NVM Express® Technical Proposal (TP)

Technical Proposal ID	8018 - NVMe/TCP - TLS updates
Revision Date	2023.09.27
Builds on Specification(s)	NVM Express TCP Transport Specification 1.0c NVM Express Base Specification 2.0c
References	TP 8025 Security Configurations

Description for Changes Document for NVM Express® TCP Transport Specification 1.0c

Description for Changes Document for NVM Express Base Specification 2.0c

Figure 433: Example of authentication transaction for NVMe/TCP

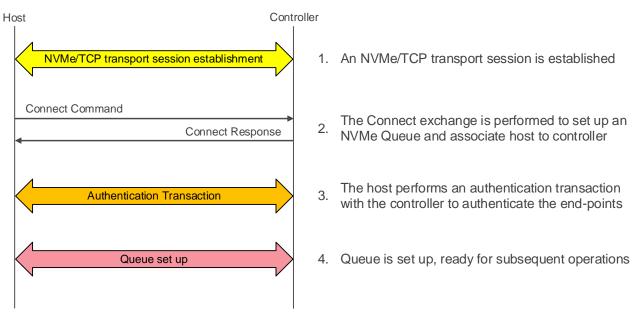
Figure 433 shows an example of authentication transaction for NVMe/TCP.

<Replace entire Figure 433 with new Figure 433 below>

Figure 436: Example of TLS secure channel concatenation with NVMe/TCPed to an authentication transaction

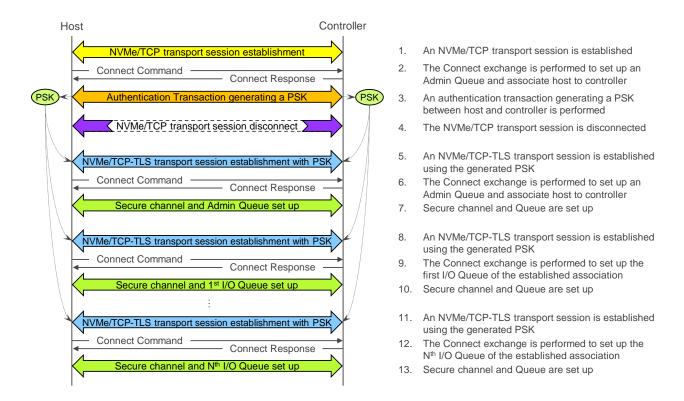
The process of generating a PSK on an Admin Queue over an insecure channel, disconnecting that Admin Queue transport connection, and setting up an Admin Queue over a secure channel established using that generated PSK is called secure channel concatenation. Figure 436 shows an example of this possibility process for TLS with NVMe/TCP, where steps 1 to 7 show TLS secure channel concatenation for the Admin Queue and steps 8 to 13 show the setup of TLS secure channels for the I/O Queues.

<Replace entire Figure 436 with new Figure 436 below>
